## Landscape Review Committee Hybrid In-Person & ZOOM Online Meeting Wednesday, May 26, 2024 - 12:00 PM

DATE:June 26, 2024TO:Landscape Review Committee MembersFROM:Taylor Graybehl, Senior PlannerSUBJECT:Tree Removal Application (L 16-24)

DATE:June 26, 2024TO:Landscape Review Committee MembersFROM:Taylor Graybehl, Senior PlannerSUBJECT:Tree Removal Application (L 17-24)

DATE:May 15, 2024TO:Landscape Review Committee MembersFROM:Taylor Graybehl, Senior PlannerSUBJECT:NW Mt. Mazama Street Tree Improvement Plan (L 13-24)

## Figure 2. Application Photos

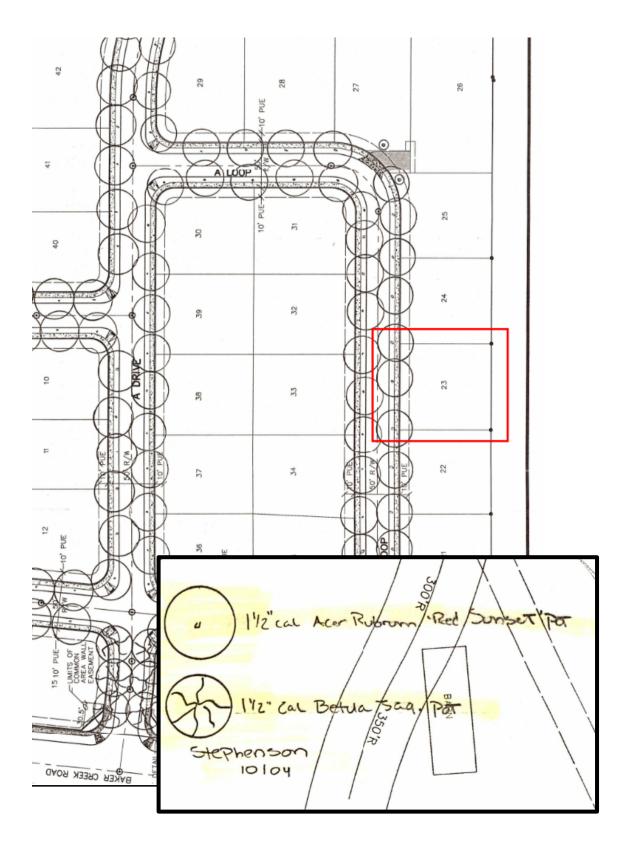
The subject site (Lot #23) is located within the Compton Crest subdivision, which was approved with a Street Tree Plan (L 23-04). The Street Tree Plan indicates Acer rubrum 'Red Sunset' to be planted within the planter strip abutting the subject site. **See Figure 3 for Street Tree Plan**.

The Applicant has identified Criterion "B" as the criteria by which the tree is to be removed.

Staff recommends the removal of the tree with the required replacement of one (1) Red Maple within the planter strip, as required by the street tree removal permit (L 23-04).

- 3. Replant with one Acer rubrum 'Armstrong' as identified on Street Tree Plan (L 23-04) within the planter strip in the same general location of the tree removed.
